MIL-R-2726/9A(SH)
3 July 1986
SUPERSEDING
MIL-R-2726/9(SHIPS)
30 June 1967

MILITARY SPECIFICATION SHEET

RECEPTACLE, ELECTRICAL, 4-PIN GROUNDED, 40-AMPERE, 450-VOLT,
ALTERNATING CURRENT (SYMBOL NOS. 758.1 AND 758.2)

Ⓐ FIGURE 1. Receptacle (metal housing and shell).

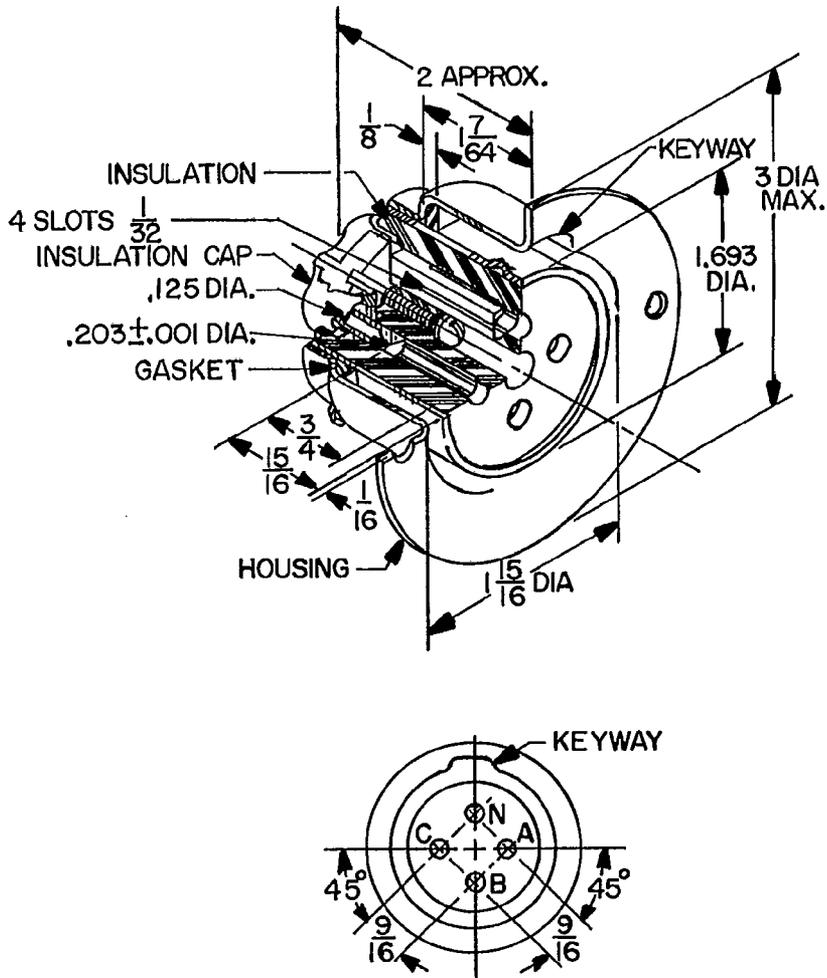
Ⓐ Symbol no. 758.1

- ③ 3. Material: Housing - optional - polyamide (nylon) or metal.
Receptacle insulation and cap - in accordance with type MAI-60 of MIL-M-14.
Contacts - in accordance with copper alloy 175, HT temper of MIL-C-46087.

4. Contact hardness: Minimum of Rockwell 80F.
- ⑤ 5. Mating plug: MIL-R-2726/3, part number M2726/3-001 (not furnished).
- ⑤ 6. Cap assembly: MIL-R-2726/13, part number M2726/13-001 (not furnished).

- ⑤ 7. Design: Plastic housing and insulation may be a one piece molded unit.
- ⑤ 8. Gasket: Neoprene, commercial (COML), durometer number 20. Lubricate with silicon compound.

- ⑤ 9. O-ring: MS28775-229
- ⑤ 10. Electrical rating: 40-ampere, 450-volt, alternating current, 60-hertz.
- ⑤ 11. Part number: M2726/9-001 (metal housing and shell).
M2726/9-002 (plastic body).

- ⑤ 12. Contact finish: Silver plate.
